# UNITED STATES PATENT AND TRADEMARK OFFICE

APPLICATION NO.	FILING DATE	FIRST NAMED INVENTOR	ATTORNEY DOCKET NO.	CONFIRMATION NO.
10/773,399	02/09/2004	Kuo-Tai Su	MR3287-12	6605

## Office Action Summary

## **DETAILED ACTION**

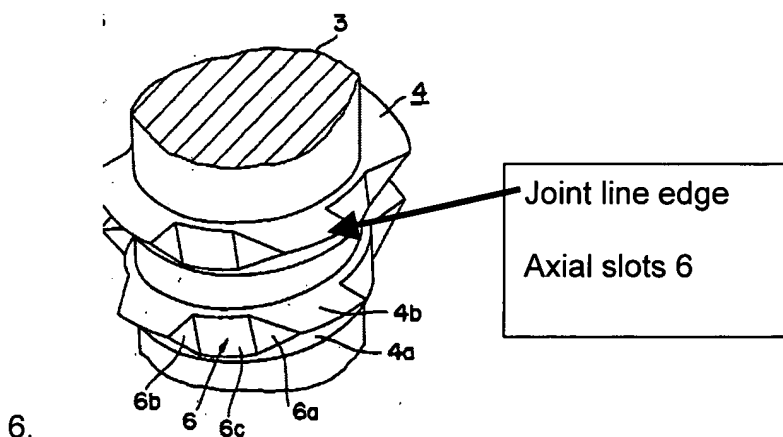
5. Claim 1 is rejected under 35 U.S.C. 102(b) as anticipated by Hiroyuki USP 5110245,

Hiroyuki Fig 2 (above) teaches a thread forming screw comprising a head (2)

with an extending shank (3) and a helically formed thread (4) wherein the thread consists of an upper flank (4b), a lower flank (4a) and an edge on the joint line of the upper and lower flanks (See Fig 2 above) and an even number of axial slots (6) formed in the thread (as best understood, Fig 3 shows an even number, four, axial slots), each axial slot beveled with a back angle (formed by surface 6a, which forms an angle sloping back relative to the joint line edge) to form a tilt surface (6a is the surface, tilted

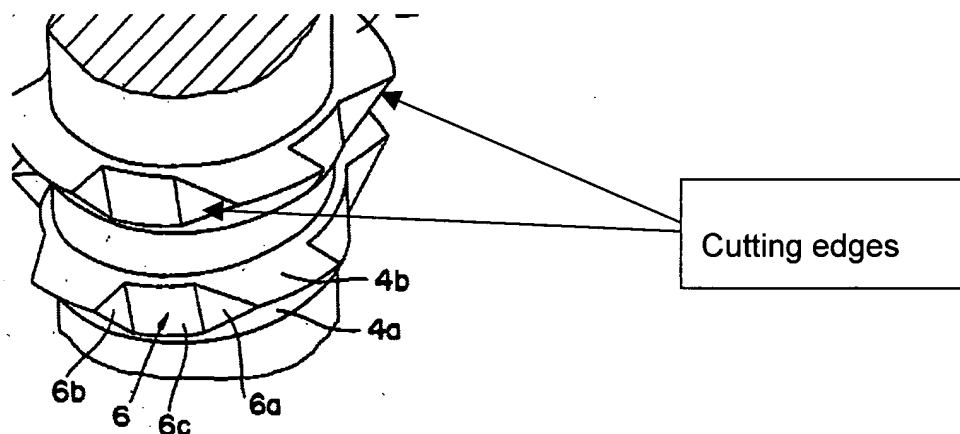
relative to either the upper or lower flank), so as to form a cutting edge from which the low flank and tilt surface extend (see also col 4 lines 3-21 – surface 6a is leading and thus inherently the edge between 6a and the low flank will be a cutting edge.
